TITLE OF INVENTION: Wine Case

Notice of Allowability For A Design Application	Application No. 29/895,014	Applicant(s) Alexander, Barry	
	Examiner AMANDA K BIRDWELL	Art Unit 2931	AIA (FITF) Status Yes

RESPONSE TO OFFICE ACTION

FIG. 3

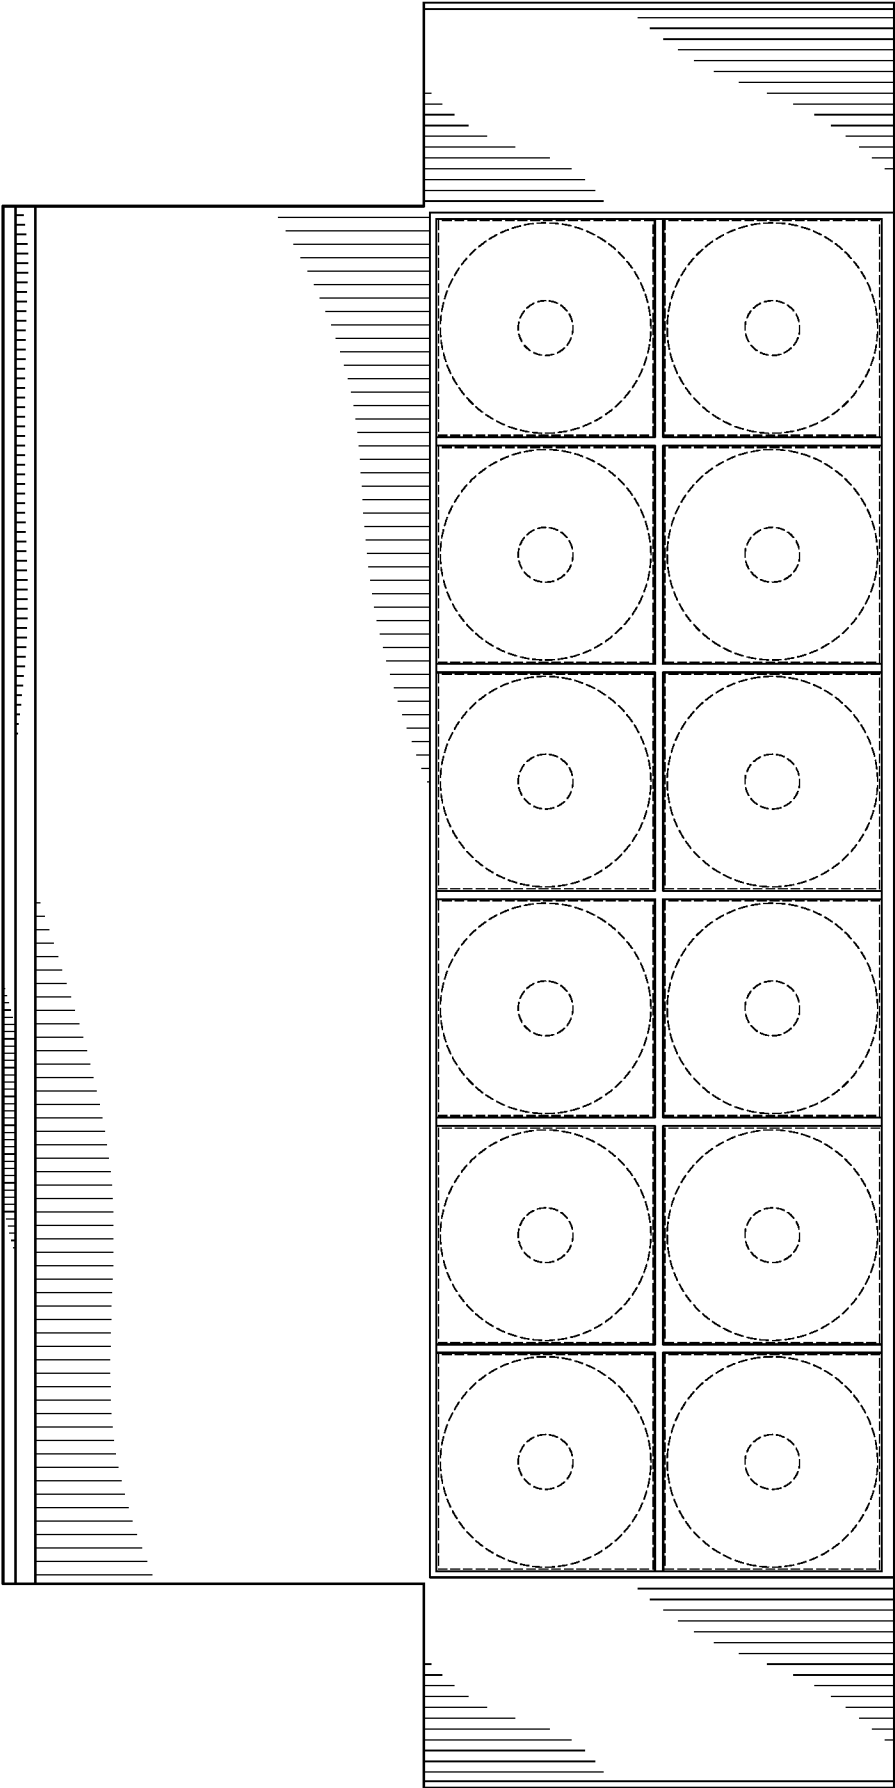
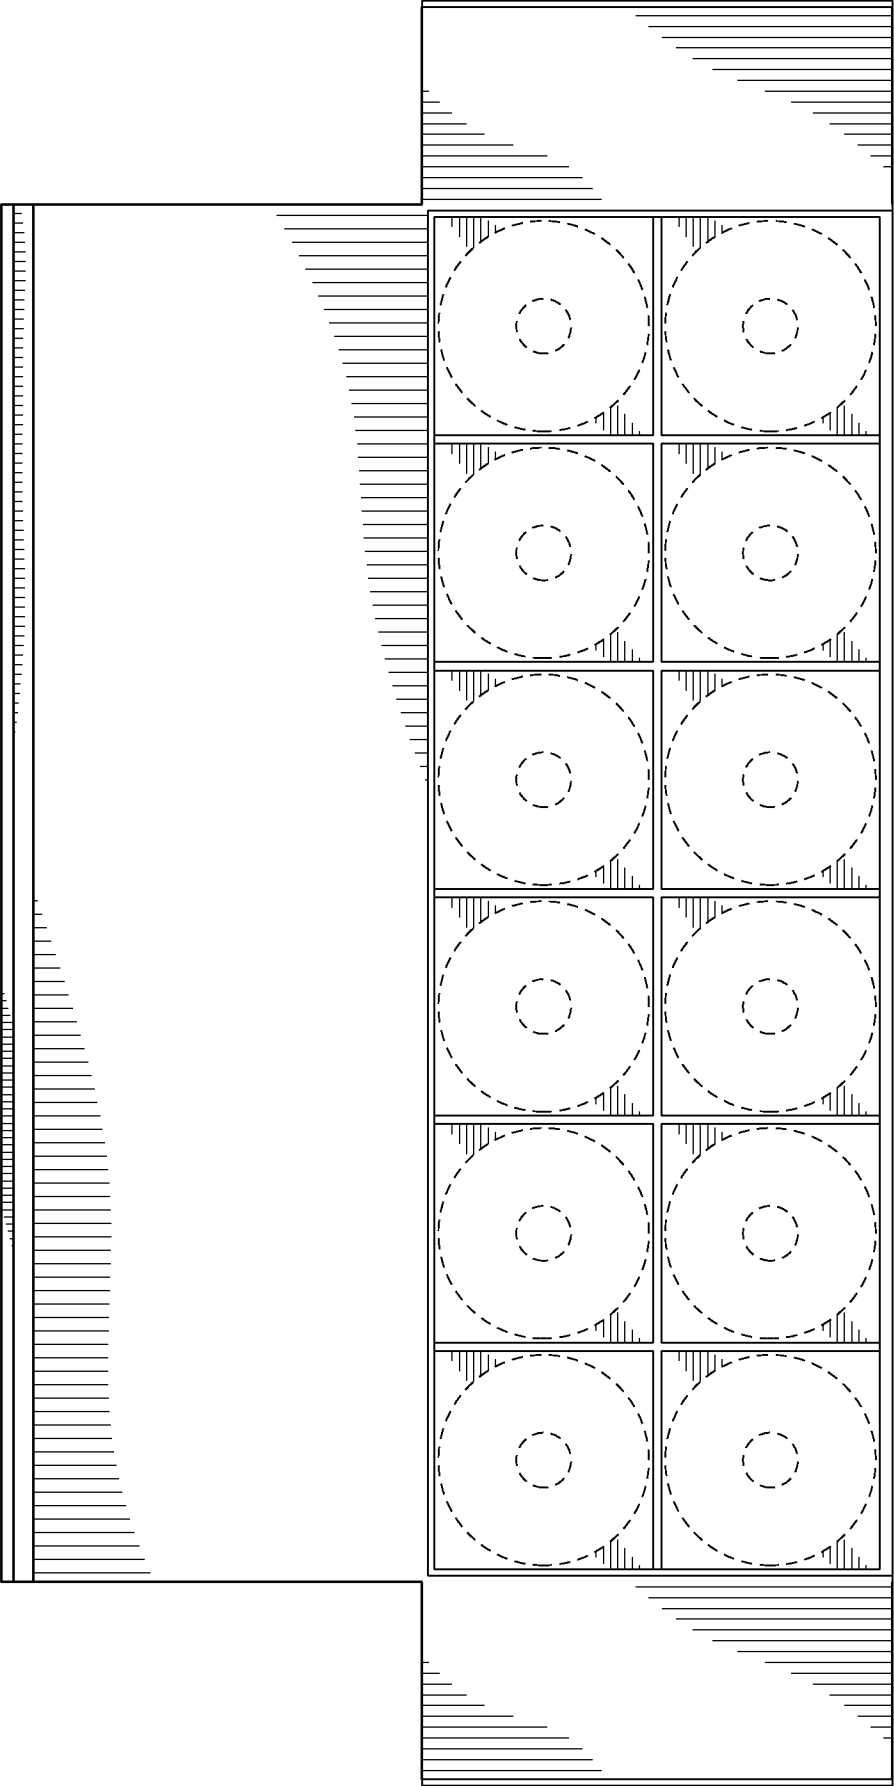
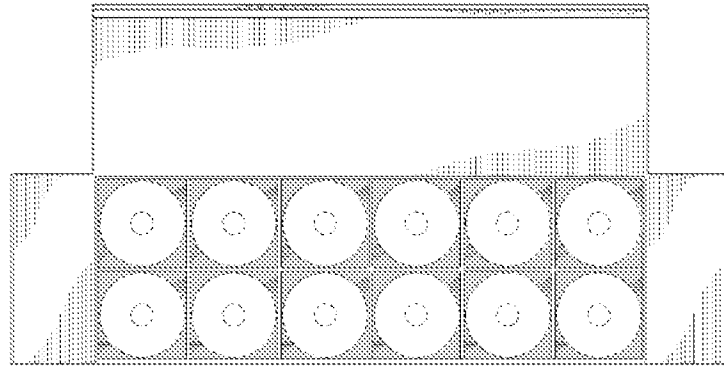
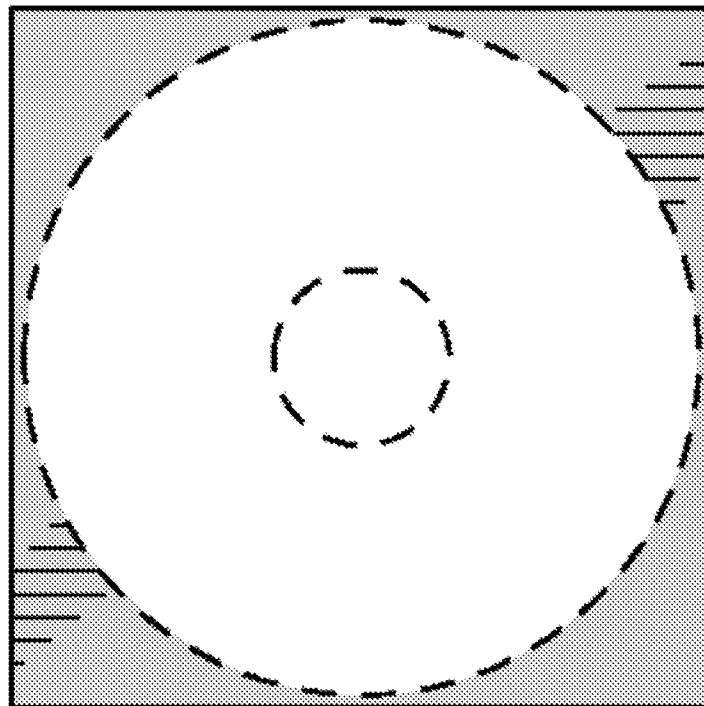
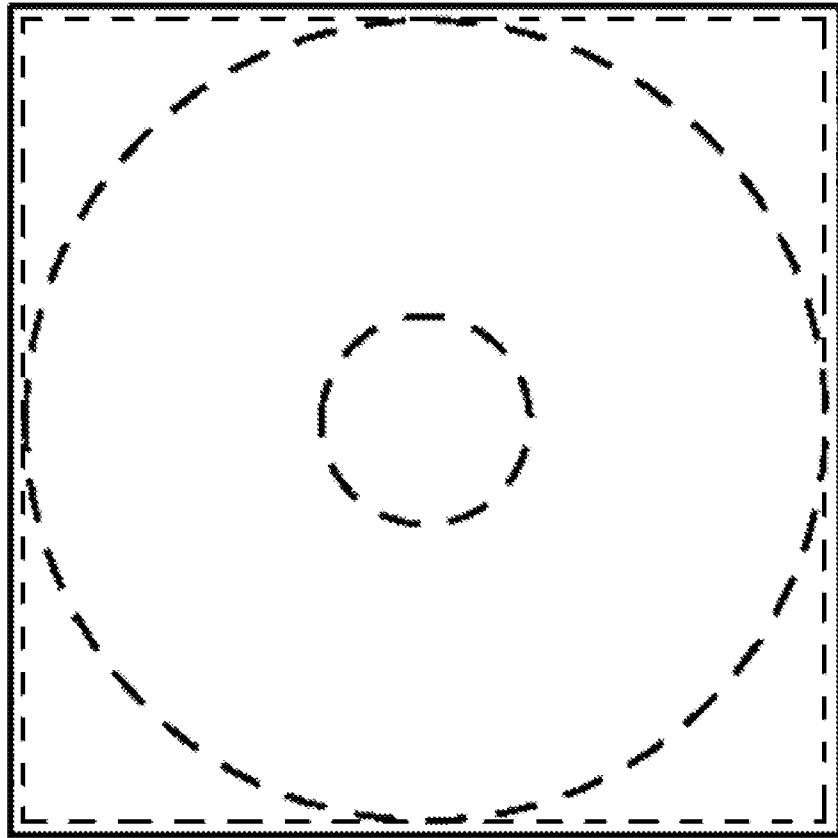
The three-dimensional form of the interior of the wine case cannot be ascertained from the perspective and top plan views. See diagram below, wherein the gray shading represents subject matter that is indefinite and non-enabled.

In response to this Office action, it is suggested that the Applicant overcome this portion of the rejection under 35 USC 112, (a) and (b), by inserting a broken line boundary adjacent to the outermost area shown in grey above, and converting any solid-line subject matter within to broken lines, so that those features form no part of the claimed design. All shading and contour lines must be removed. Inserting this boundary to illustrate unclaimed subject matter will meet the written description requirement of 35 USC 112(a). See proposed example image below, which is solely for purpose of explanation.

Figure 3 (formerly Figure 28) has been amended to remove the gray shading around the bottles and insert a broken line boundary indicating unclaimed subject matter in its stead, as recommended by the examiner. This amendment is supported by original Figure 26.

The examiner has rejected the claim as indefinite and non-enabling because of certain shading on Figure 28 (now Figure 3). New Figure 3 has been revised in accordance with the examiner's recommendation to overcome the rejection. The examiner has rejected the claim as indefinite because the closed flap depictions in Figure 33 (now Figure 8) displayed the smaller portion of the top flap as inserted into the case, which is not possible given that the illustrated side flaps cover the entire width of the box and the width of the top flap in Figure 30 is too long. Amended Figure 8 shows the smaller portion of the top flap outside the box, which is consistent with the dimensions in Figures 3 and 5.

FIG. 5

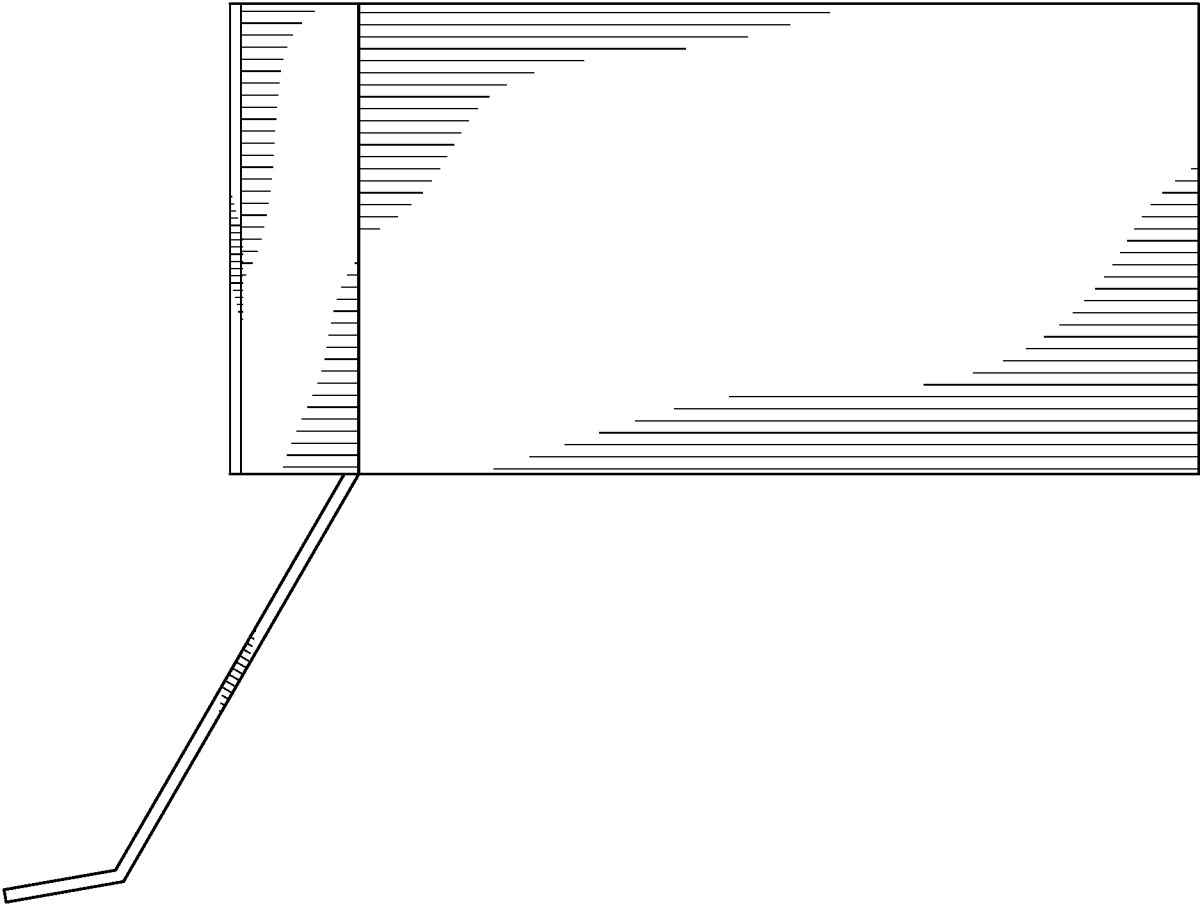
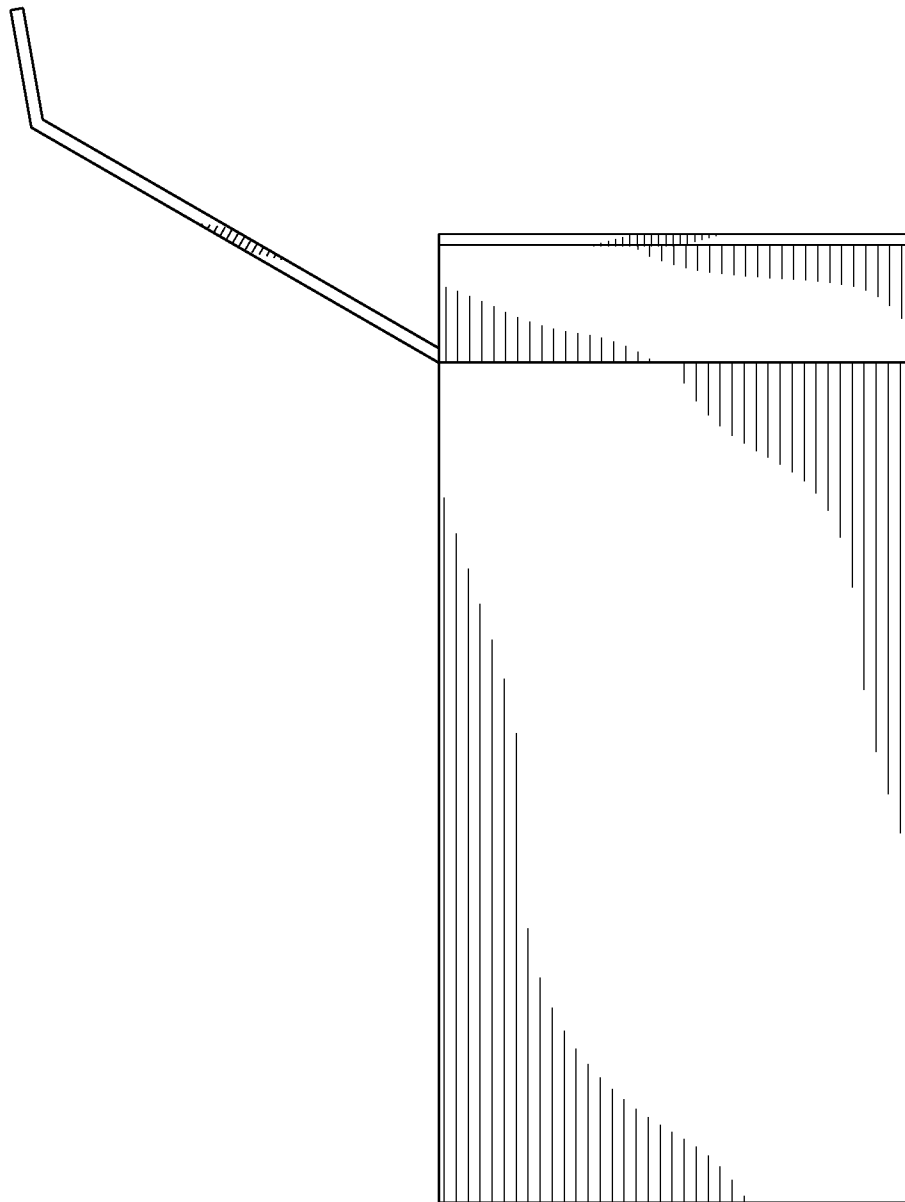
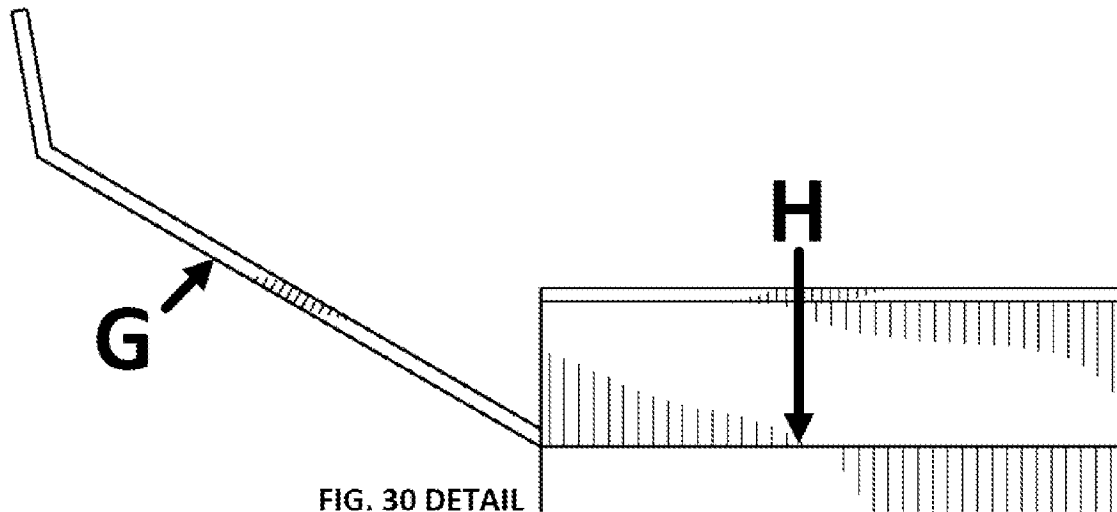
FIG. 30 shows the appearance of the wine box inconsistently with the other drawings.

Specifically, knowing that Fig. 33 shows the case tightly sealed, with the smaller portion of the top flap understood to be inserted into the case (Arrow A above), it's understood that the largest portion of the top flap (Arrow G) must be slightly shorter than the width of the **interior** of the crate (Arrow H). However, Fig. 30 shows the two to be equal in length, conflicting with the closure style seen in Fig. 33. See diagrams below.

Figure 5 (formerly Figure 30) has been amended to match the width dimension of the top to the width dimension of the box, as recommended by the examiner. This amendment is supported by original Figures 26-28.
